Access Compliance Report

Public Rights-of-Way

Intersection ID: 42370	Main Street: BENTGRASS_RUN_DR	Cross Street: WHISTLER'S_CHASE_DR	Location: S
ADA ID: E2F3D088F274	Ramp Type: PerpDiag	Initial Pass/Fail: Fail	Overall Compliance: No
		Severity Score: 10

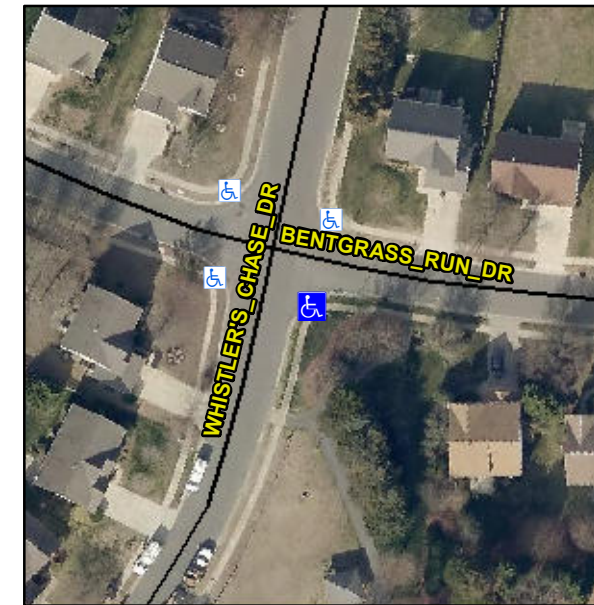
R304.5.1, R304.5.3

Compliance	Description	Data	Compliance	Description	Data
N/A	Ramp Length (in)	39.0	Yes	Ramp Slope (%)	5.5
No	Ramp Width (in)	46.0	No	Ramp XSlope (%)	4.4
N/A	Flare Type LT	N/A	N/A	Flare Type RT	N/A
N/A	Flare Slope LT (%)	N/A	N/A	Flare Slope RT (%)	N/A
N/A	Flare Traversable LT?	N/A	N/A	Flare Traversable RT?	N/A
N/A	Landing Length (in)	N/A	N/A	DWS Provided?	N/A
N/A	Landing Width (in)	N/A	N/A	DWS Contrast?	N/A
N/A	Landing Slope (%)	N/A	N/A	DWS Length (in)	N/A
N/A	Landing X Slope (%)	N/A	N/A	DWS Full Width?	N/A
N/A	Landing Curb? (Y/N)	N/A	N/A	DWS Offset (in)	N/A
N/A	Shared Landing?	N/A			
N/A	Gutter Ponding?	N/A	N/A	Gutter Slope (%)	N/A
N/A	Gutter Lip Ht (in)	N/A	N/A	Gutter X Slope (%)	N/A
N/A	Painted X Walk1?	No	N/A	Painted X Walk2?	No
	X Walk 1 Direction	To NE		X Walk 2 Direction	To NW
N/A	X Walk 1 Width (in)	N/A	N/A	X Walk 2 Width (in)	N/A
	X Walk 1 Slope (%)	0.1		X Walk 2 Slope (%)	2.4
	X Walk 1 X Slope (%)	3.1		X Walk 2 X Slope (%)	0.2

Remove & Replace Curb Ramp With Two New Directional Ramps or Equivalent.
